CITY OF CODY
PLANNING, ZONING AND ADJUSTMENT BOARD
TUESDAY DECEMBER 28, 2021
CITY HALL COUNCIL CHAMBERS @ 12:00 NOON

CITY OF CODY PLANNING, ZONING AND ADJUSTMENT BOARD STAFF REPORT

MEETING DATE:	DECEMBER 28, 2021	TYPE OF ACTION NEEDED	
AGENDA ITEM:		P&Z BOARD APPROVAL:	
SUBJECT:	FINAL PLAT AND CONSTRUCTION PLANS FOR THE MOUNTAIN VIEW 29 SUBDIVISION— A 15-LOT SUBDIVISION. SUB 2021-03	RECOMMENDATION TO COUNCIL:	X
PREPARED BY:	TODD STOWELL, CITY PLANNER	DISCUSSION ONLY:

FINAL PLAT

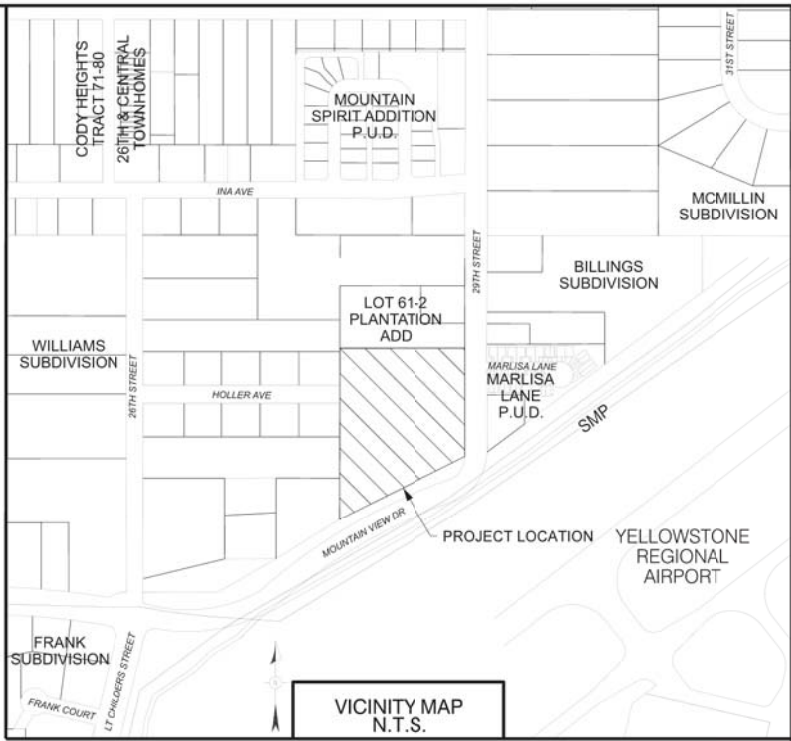
1. The final plat needs the following edits, in addition to those noted above.
 - a. Add the record dimensions to the perimeter of the plat.
 - b. Adjust the lines of Lots 1 and 14 for the street curve.
2. The construction plans need the following edits, in addition to those noted above.
 - a. A 2" flushing tap will be needed in the new water main on Lot 15 in order to disinfect and flush the line. The tap can be abandoned once the water main is put into service.

UTILITY PLAN

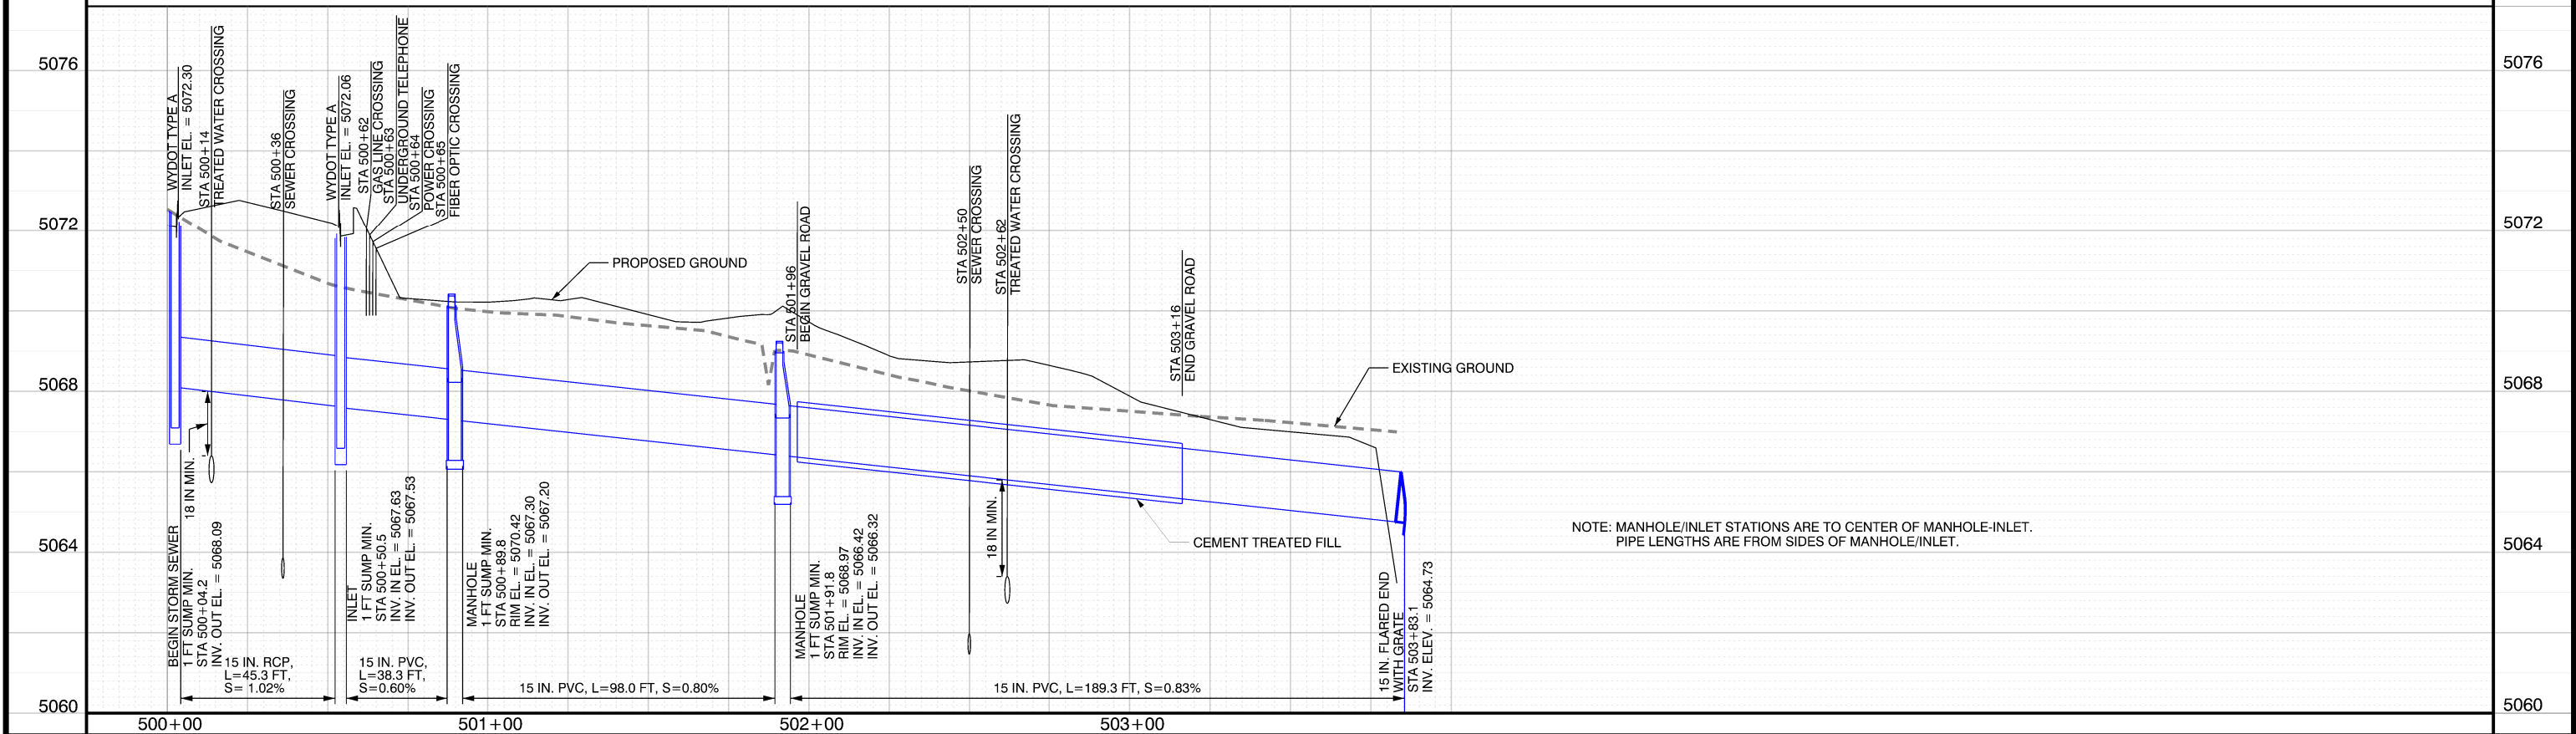
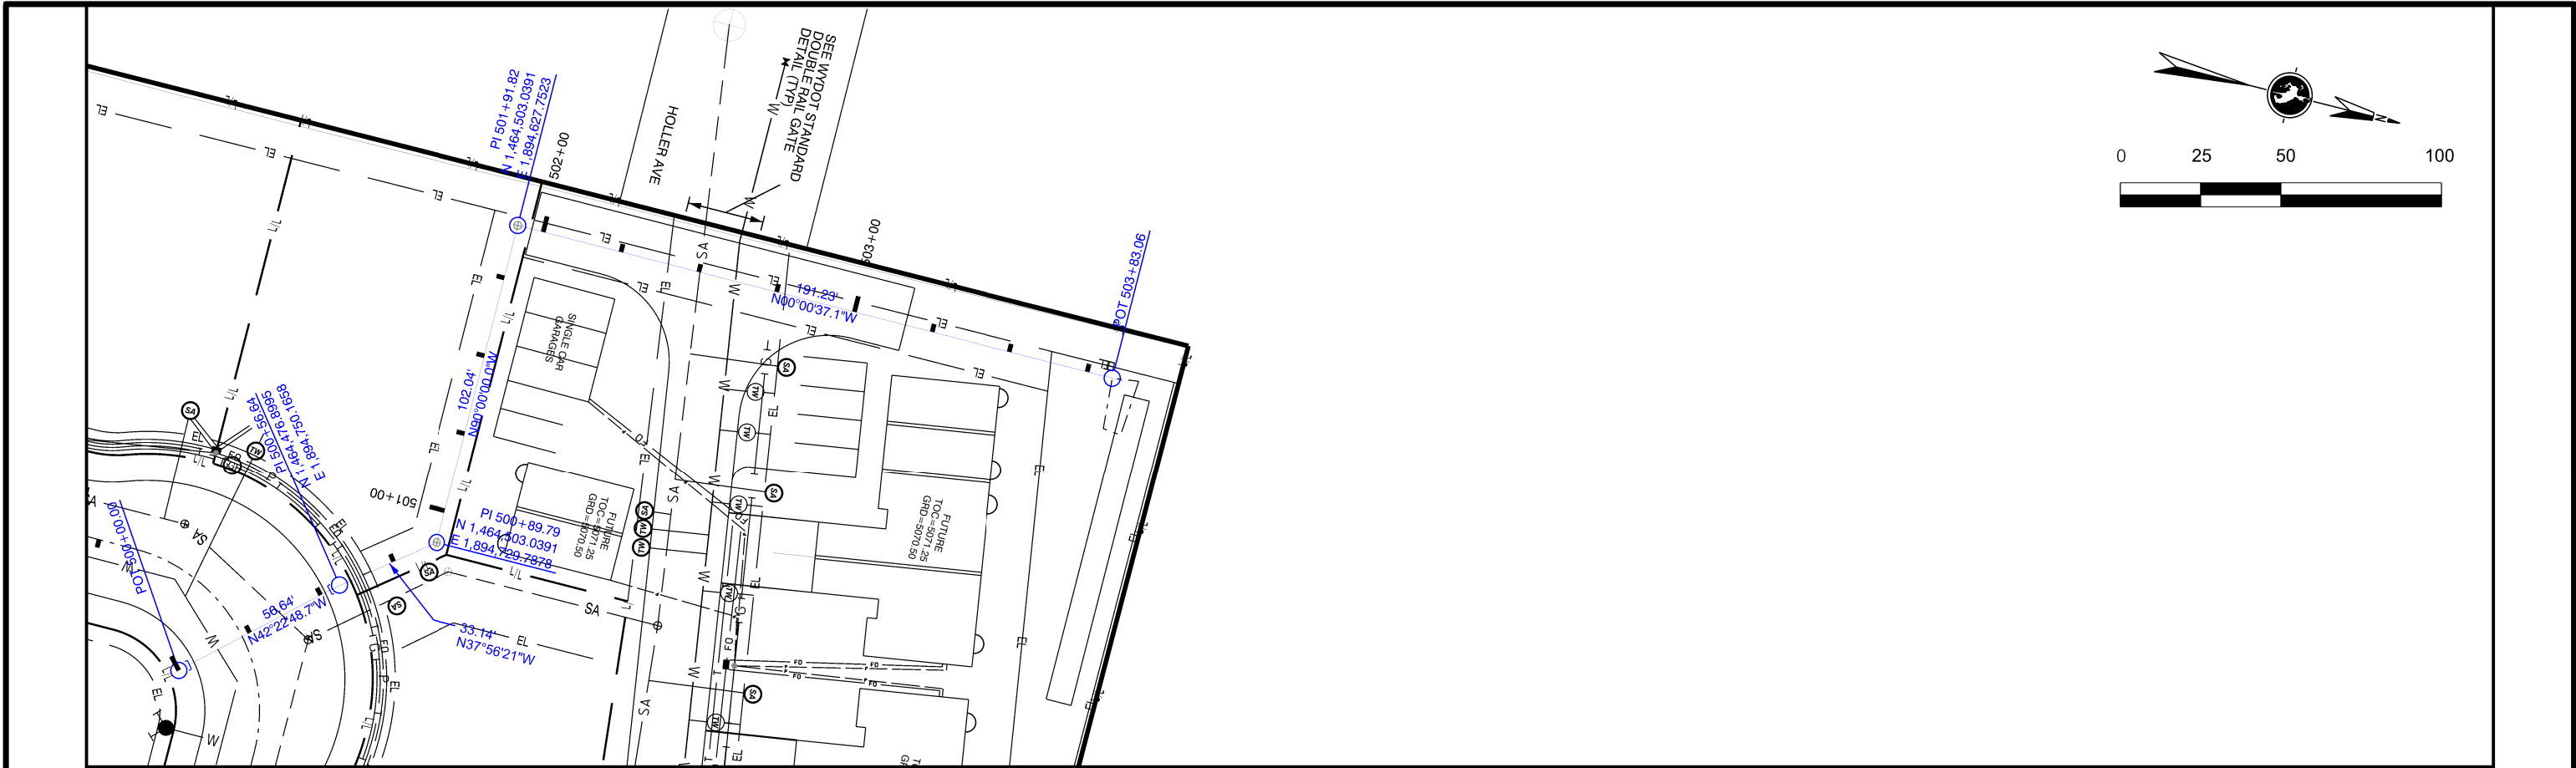
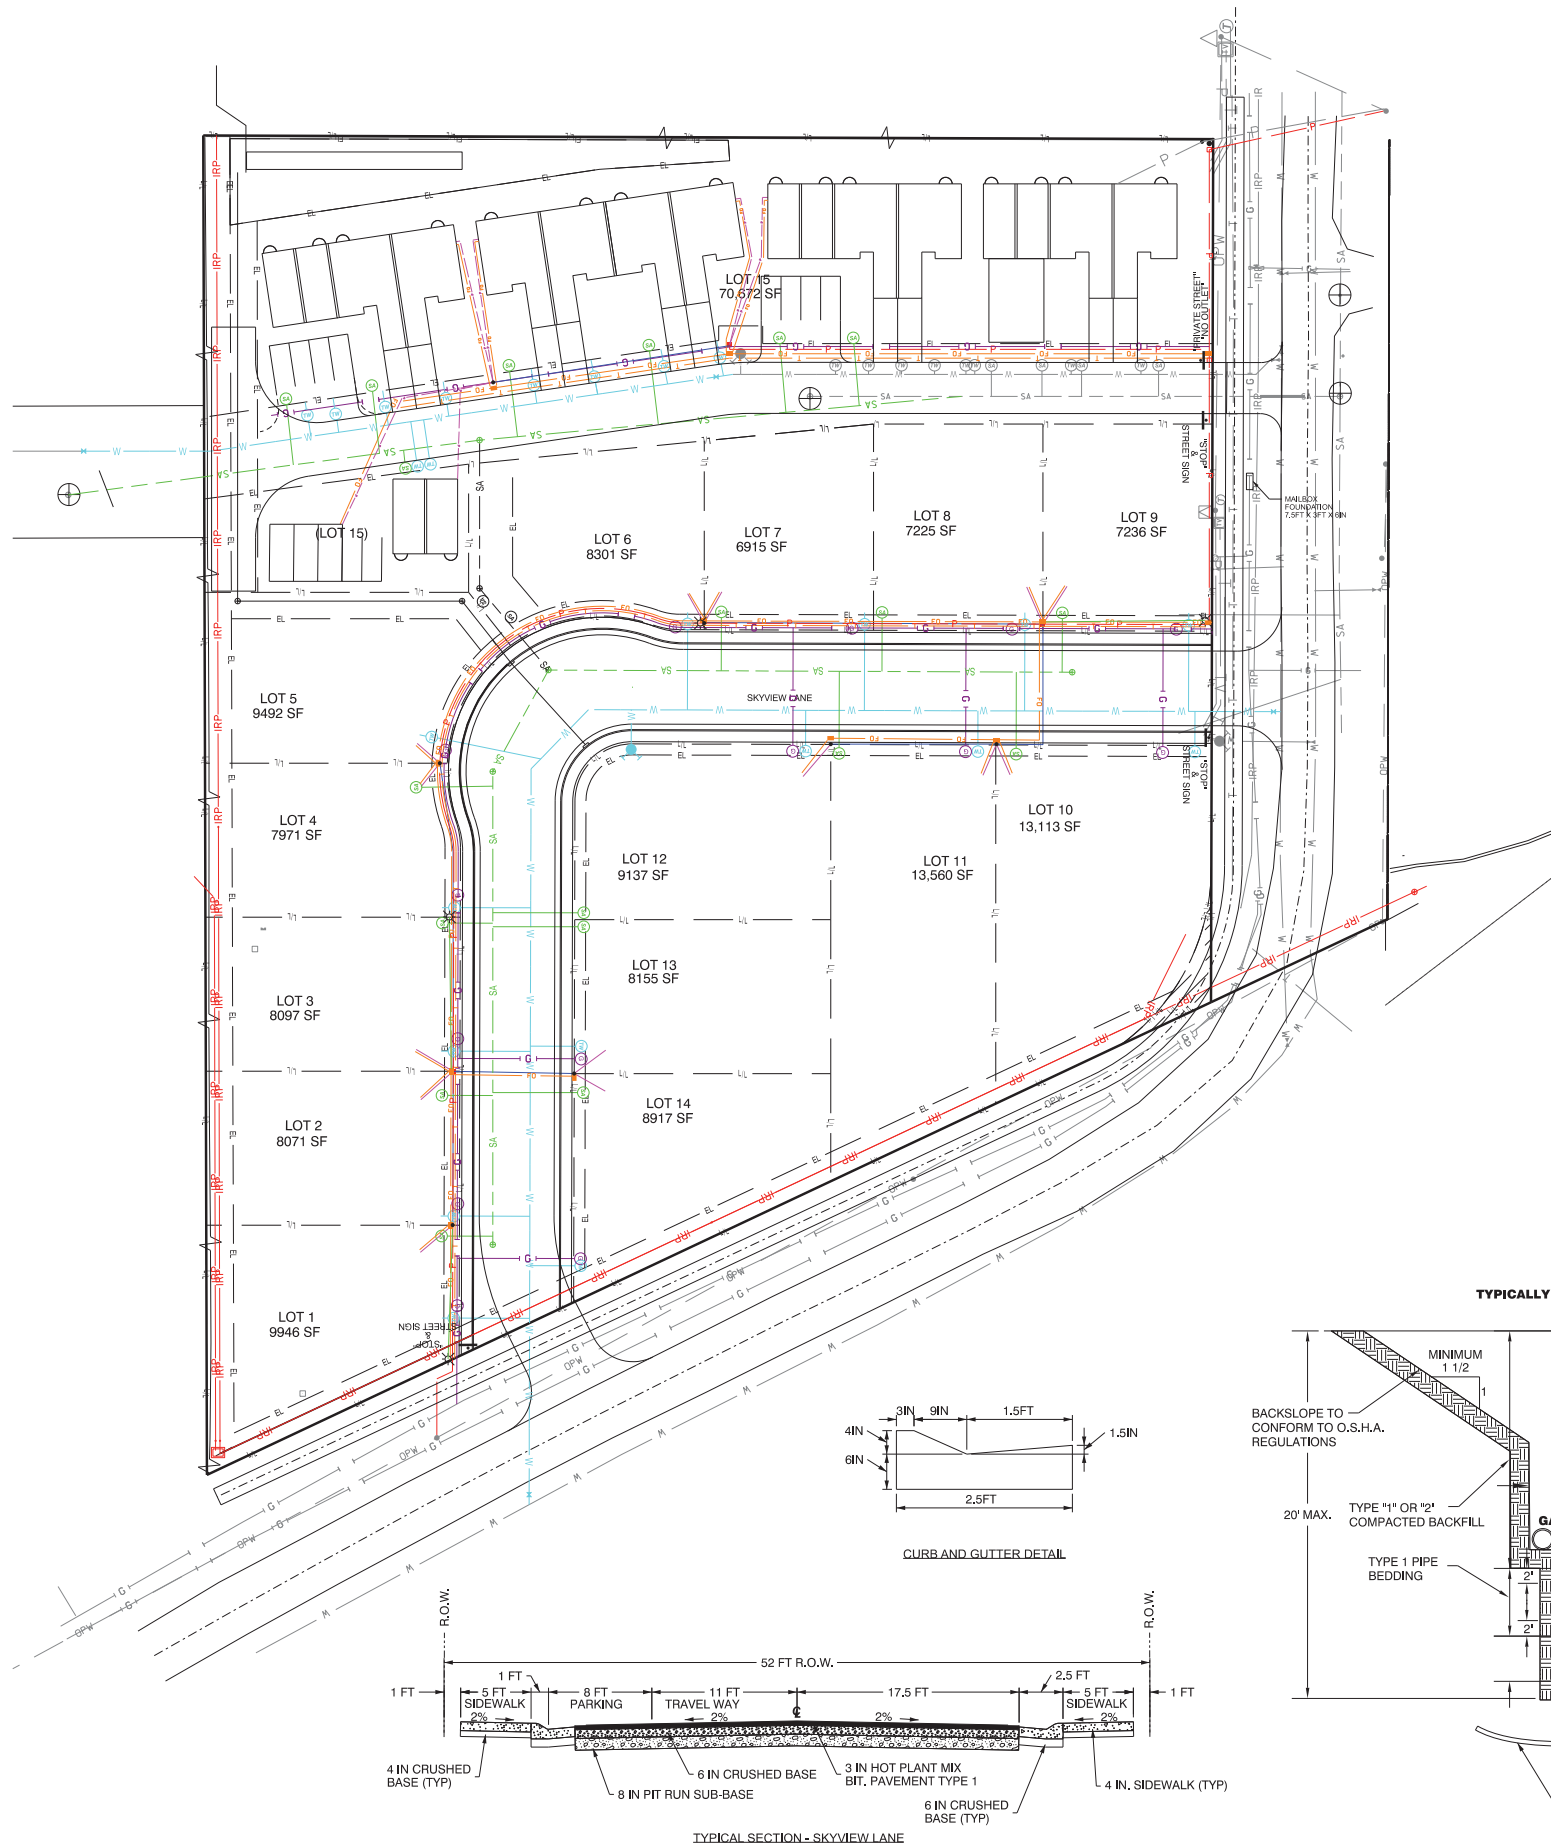
- i) Clarify the street section detail (51' right-of-way).
Status: Met. Street section is shown on the Utility Plan sheet (last sheet of plans).
 - j) Since the plans for Lot 15 are not set up to allow for future subdivision (inadequate access street, power layout, etc.), individual sewer services are not required to be provided to each individual unit. Units within the same building could share sewer.

- k) In order to avoid having to dig under the dry utilities to connect to the sewer and water service stubs, extend the sewer service to the back side of the dry utility easement and extend a "pigtail" from the curb stop at the back of the sidewalk under the dry utility trench.

Status: The concept is shown on the Utility Plan sheet, but the curb stop location is not included. Add language that "Curb stops are to be located at back of sidewalk."

- b. Clarify on the utility plan the required installation of the new underground primary and secondary electrical lines to cross 29th Street; the accompanying secondary pedestal and service change for the existing 4-plex; and, removal of the abandoned pole and lines.

- c. Add the streetlight symbol to the legend on the utility plan.
 - d. Finish coordinating the valving plan for the Mountain View Drive water line, and update the plans accordingly, if needed.

3. On the Utility plan:
 - a. Clarify on the utility plan the required installation of the new underground primary and secondary electrical lines that will cross 29th Street; the accompanying secondary pedestal and service change for the existing 4-plex; and, removal of the abandoned pole and lines.

- b. Add the streetlight symbol to the legend on the utility plan.
 - c. Add language that, "Curb stops are to be located at back of sidewalk."
4. Finish coordinating the valving plan for the Mountain View Drive domestic water line, and update the plans accordingly, if needed.

DRAINAGE PLAN

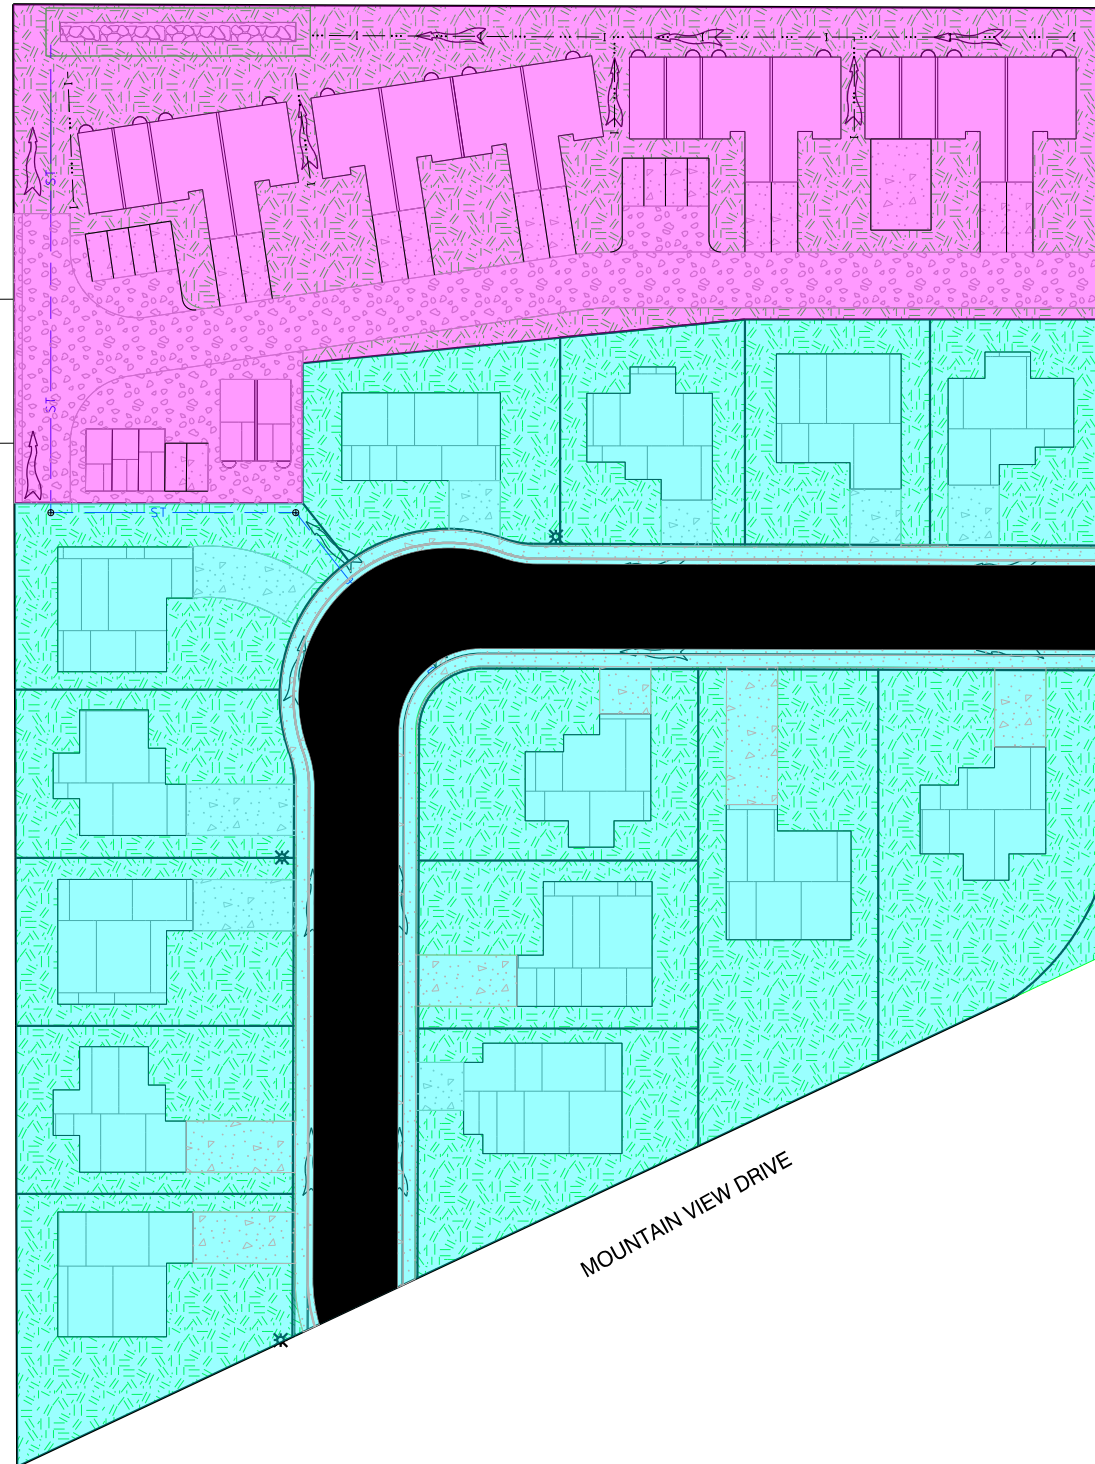
Status: A stormwater report and drainage plan have been provided. The drainage plan accommodates the 100-year, 2-hour storm event. There is one part of the plan that needs a little more work—specifically the T-turnaround at the west end of the Lot 15 driveway does not clearly identify how surface water will be able to flow across it and to the infiltration trench. The area of the T-turnaround is restricted from being lowered due to exiting irrigation pipes. It appears the solution would be to grade the area in a manner that inlets could be provided to capture the surface water and take it down into the stormwater pipe that runs below the T-turnaround area and over to the infiltration trench.

6. Update the grading/drainage/stormwater plan in the area of the "T" turnaround on Lot 15 to clearly capture the surface water flow in that area and take it to the infiltration area (see discussion in status of preliminary plat condition #8).
